Appendix A: Request for Variance

Infrastructure Standards for Telecommunications Spaces v4.0

Request Date:	9/12/24
Government POC:	Tim Stark
Org Represented:	Castle Point VA Medical Center
Email Address:	Timothy.Stark@va.gov
Contact Phone:	914-776-4654
Site, Building #, Room, Mission of the Facility Where Requested (also note admin vs medical specific use):	Castle Point VA Medical Center B.15E - TR 011A & TR 315 B.16 - TR F100 B.17 - TR G-203 B.18 - TR 39
Variance Requested:	B.15E & B.15H - TR 011A serves both Buildings 15E and 15H. While technically separate buildings, 15E/H share corridors and exterior walls. There is ample coverage provided from a single TR serving both buildings. B.15E & B.15H - TR 315 serves attic. There is limited programming space on the 4th floor (attic); 3rd floor TR has sufficient capacity to serve any anticipated service needs in the attic. B.16 - TR F100 serves 2nd and 3rd floors. There is limited space available on the 2nd and 3rds floors due to programming needs. It is anticipated that ~75-100 ports are needed for the 1st, 2nd, and 3rd floors combined, which can be served appropriately from a single rack in F100. B.17 - TR G-203 serves the 2nd and 3

1 LEVEL 01 - FLOOR PLAN

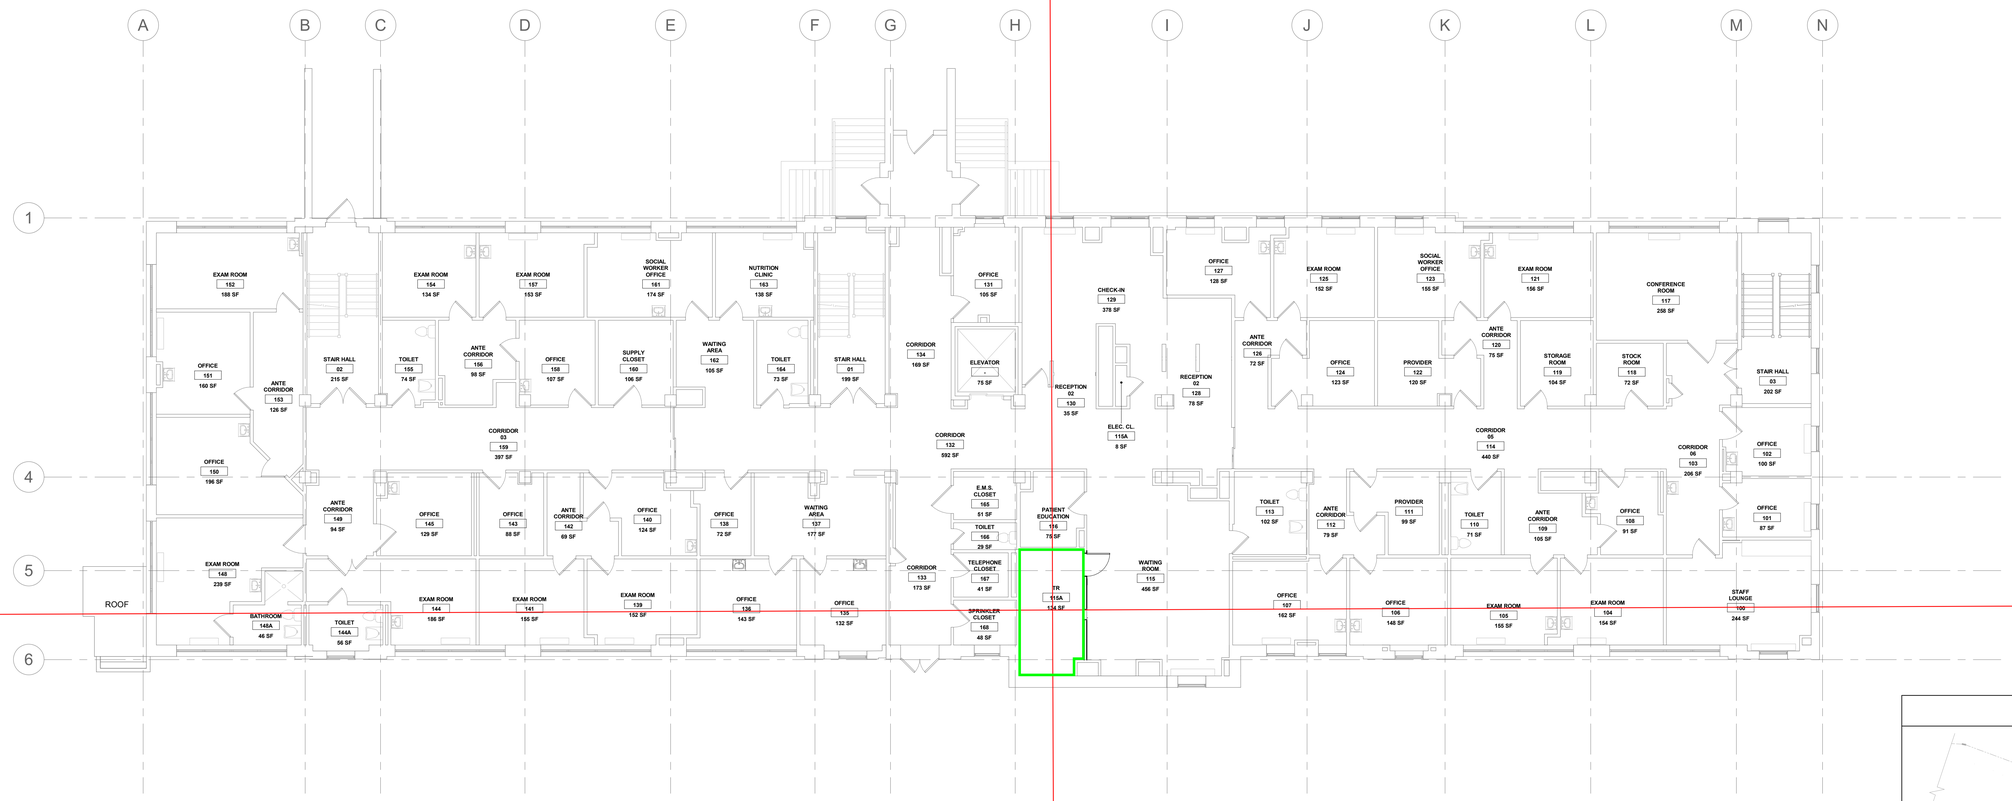
1. VA APPROVED TR 115A (134 SQFT).
2. TR TO BE BUILT IN RM D-115A. PROJECT WILL MOVE NURSING POD CURRENTLY LOCATED IN THIS WAITING ROOM.
3. TR MEETS THE VA STANDARD FLOOR AREA REQUIREMENTS FOR EXISTING HEALTHCARE BUILDINGS OF 100 SQFT.
4. TR DOES **NOT** MEET THE VA STANDARD MINIMUM FORM FACTOR REQUIREMENTS OF A 10'X10' FOOTPRINT.

1 LEVEL 02 - FLOOR PLAN

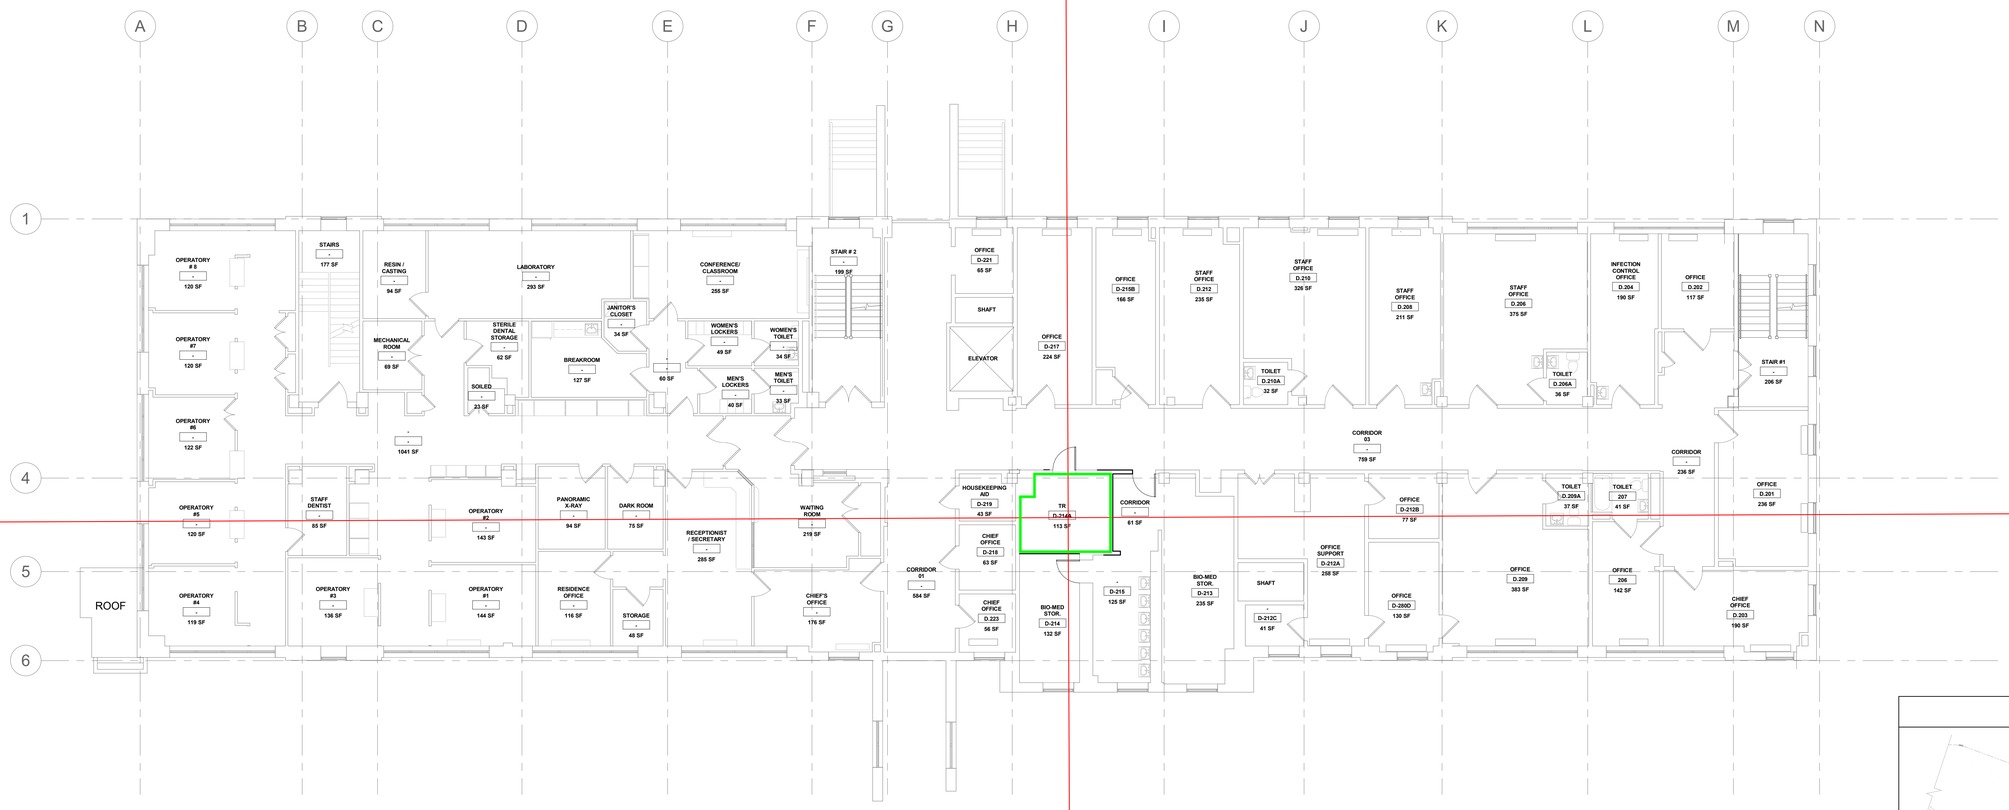
1. VA APPROVED TR D-214A (113 SQFT).
2. TR MEETS THE VA STANDARD FLOOR AREA REQUIREMENTS FOR EXISTING HEALTHCARE BUILDINGS OF 100 SQFT.
3. TR MEETS THE VA STANDARD MINIMUM FORM FACTOR REQUIREMENTS OF A 10'X10' FOOTPRINT.

1 PENTHOUSE - FLOOR PLAN
1/8" = 1'-0"

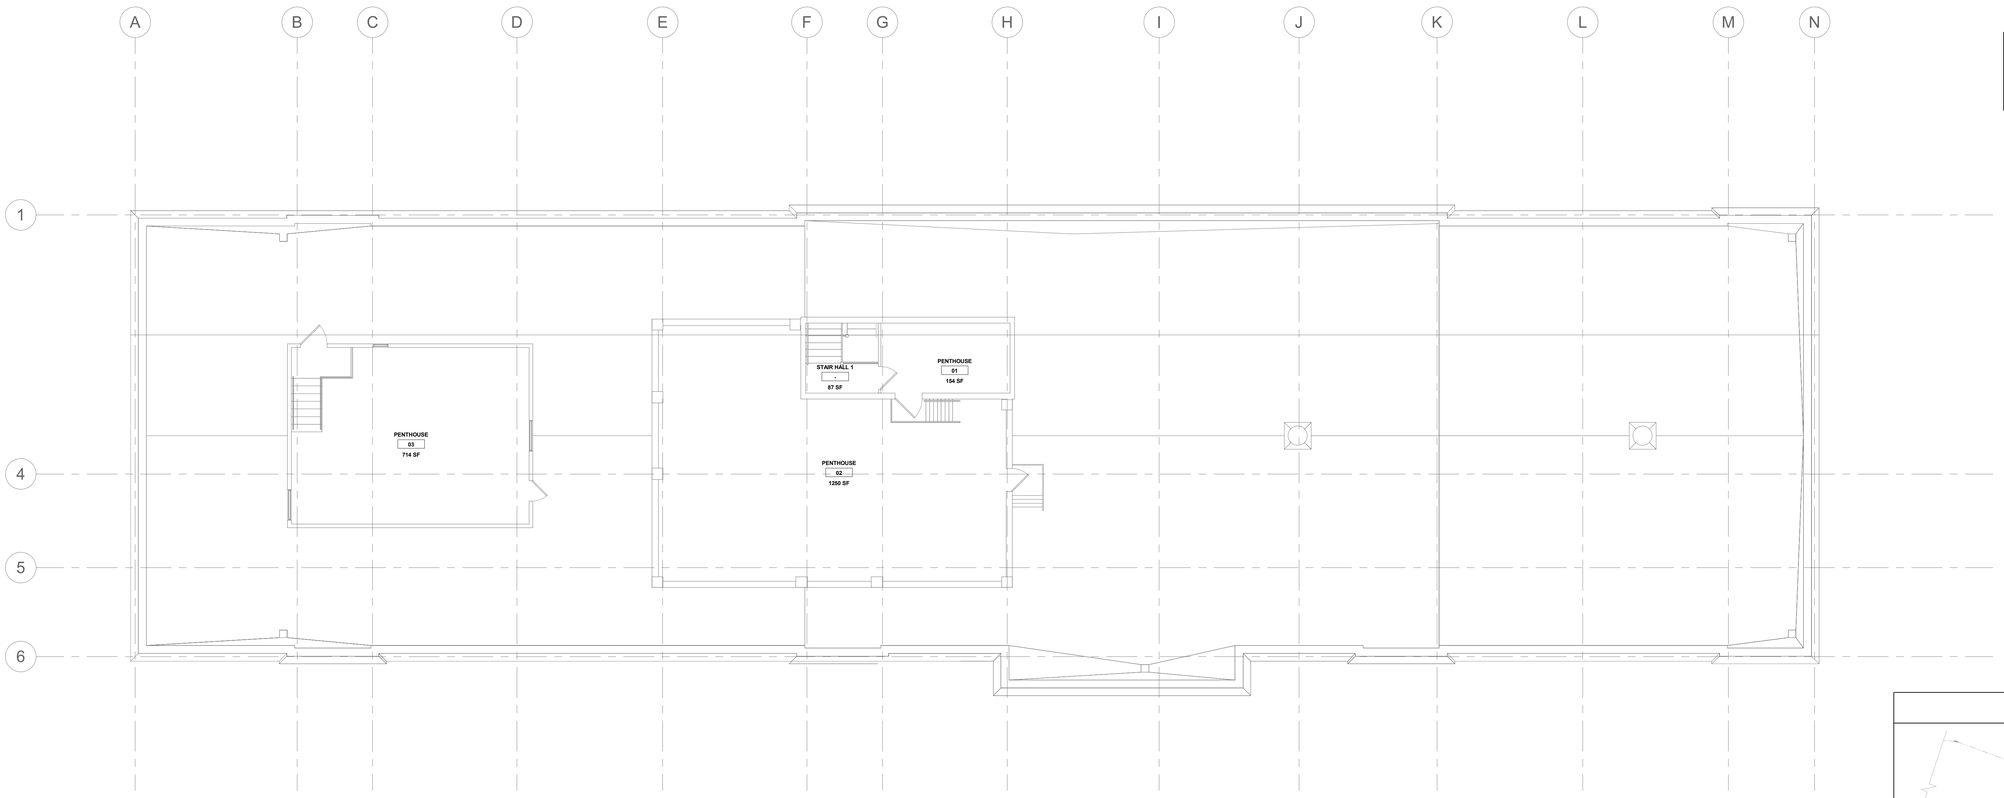
BLDG 18 - LEVEL 04
1. NO CURRENT PROGRAMMING NEEDS ON PENTHOUSE FLOOR; ANY PROGRAMMING NEEDS WITH BE SERVICED FROM TR 314CA ON LEVEL 03.
